ASI  
14

1 BUILDING E - STAIR (TYPICAL) - LEVEL 1 PLAN  
SCALE 3/8\"/>

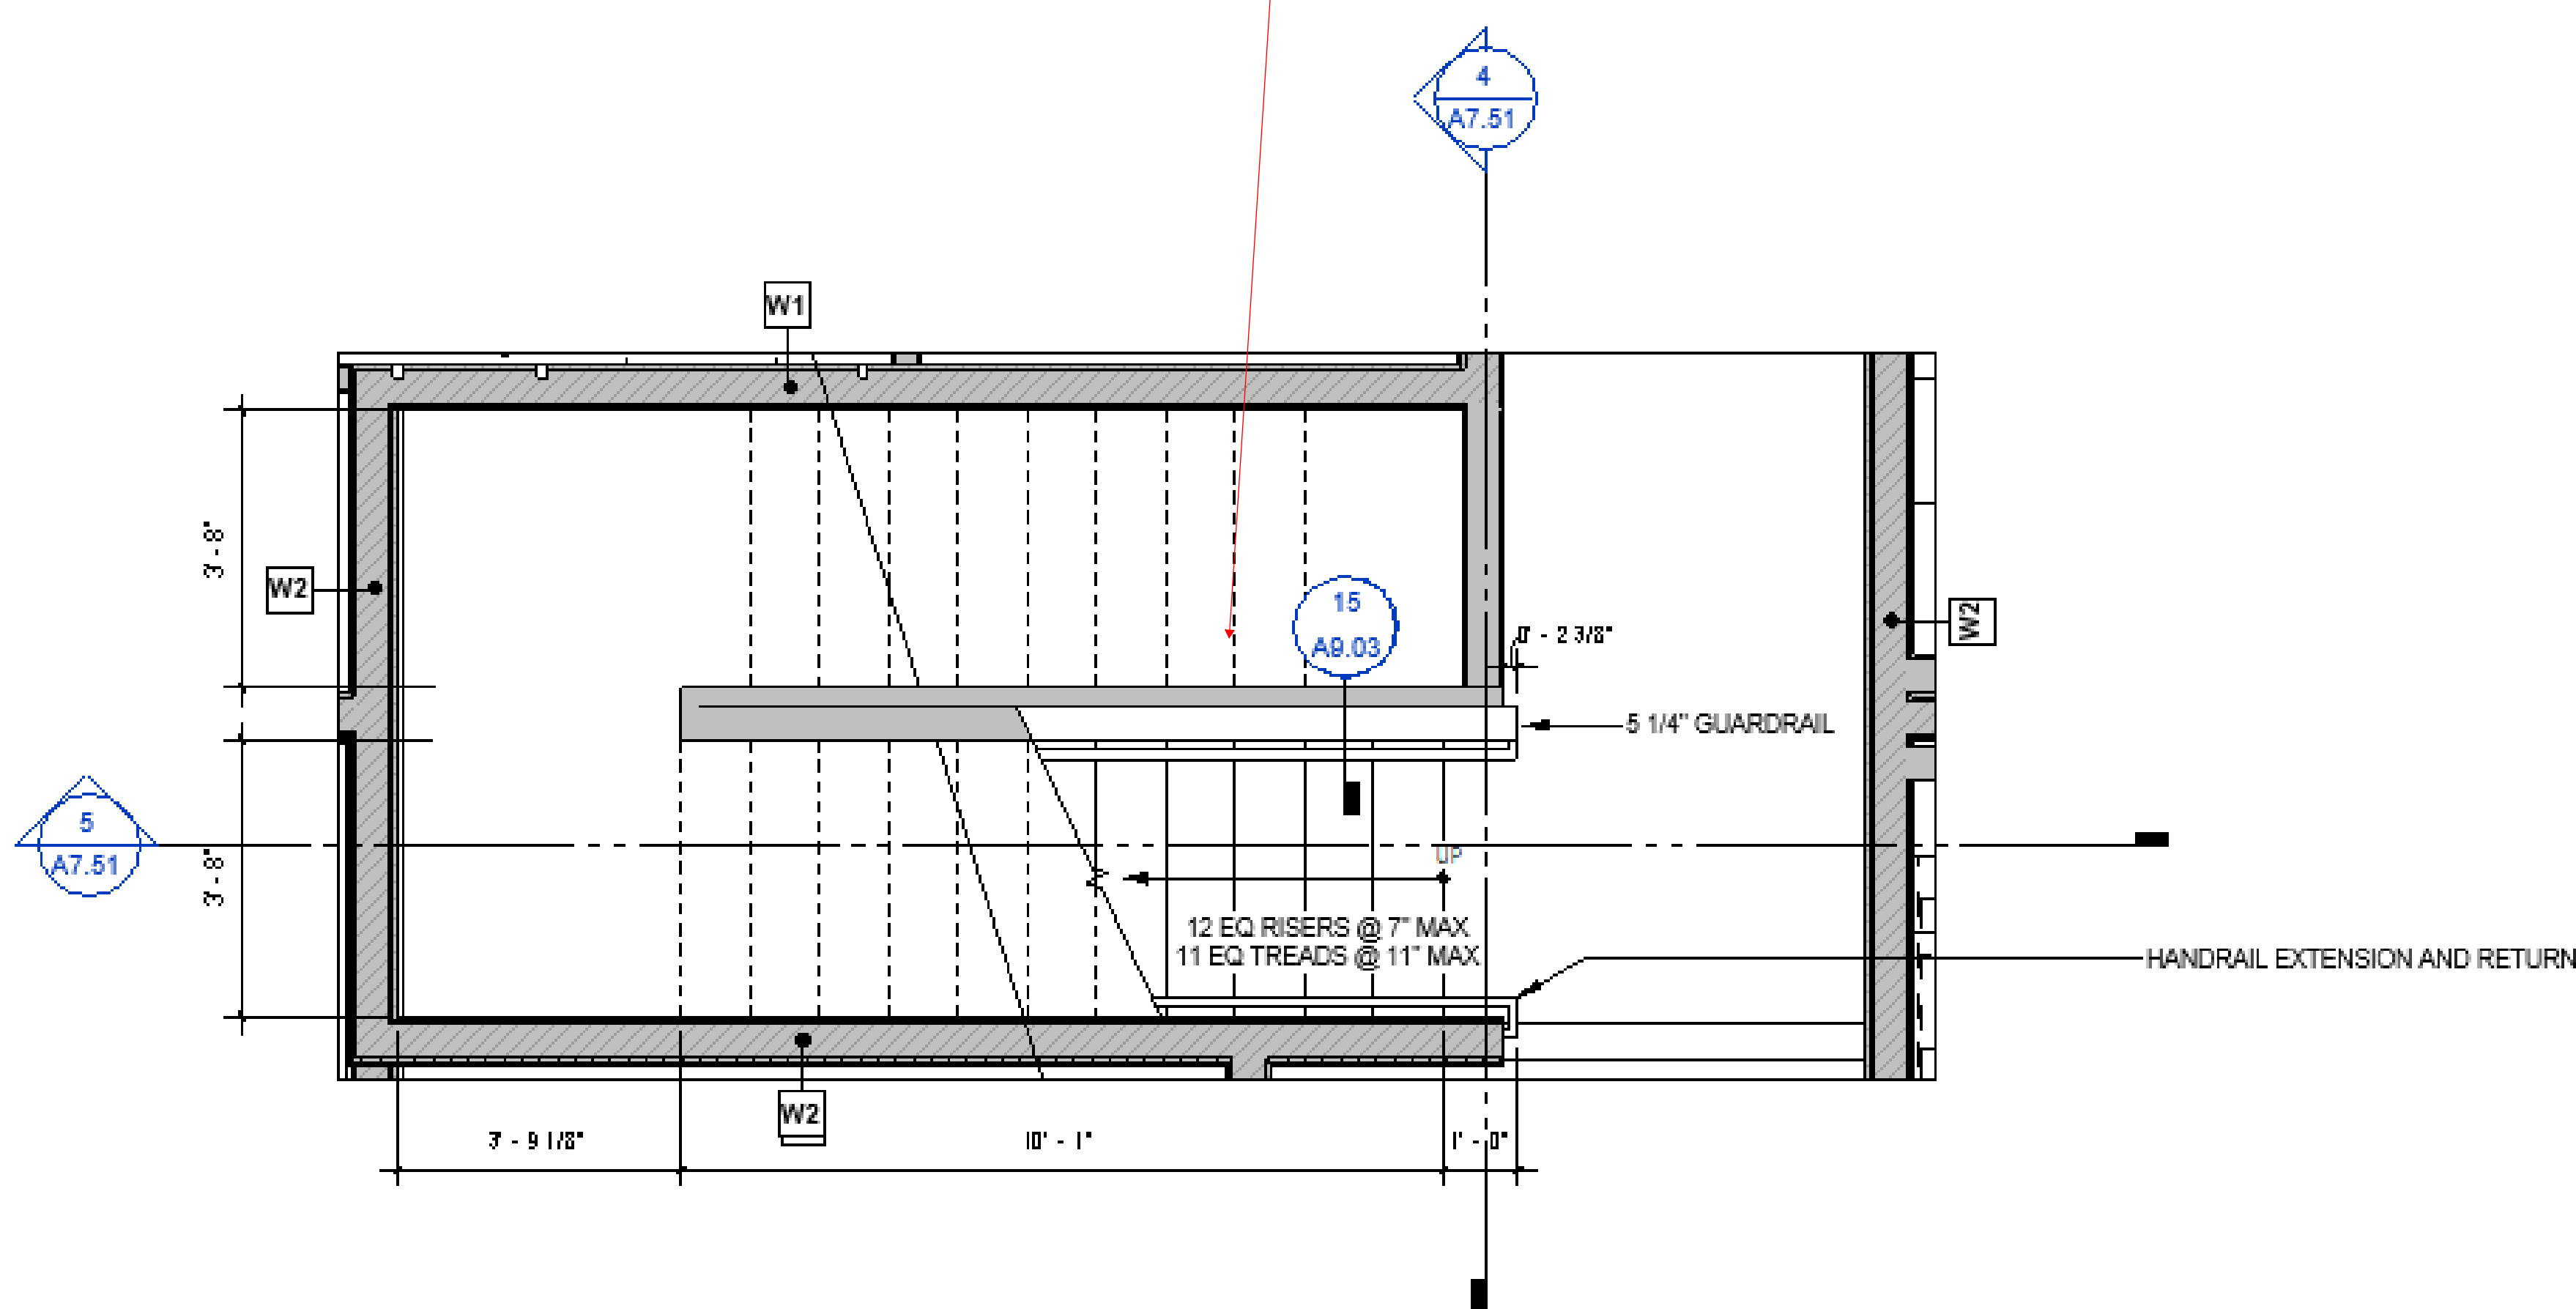
THE BOTTOM OF THE STAIRS IN BUILDING E SHOULD BE ENCLOSED. ADD WALL TO ENCLOSE STAIRWELL AS SHOWN BELOW.
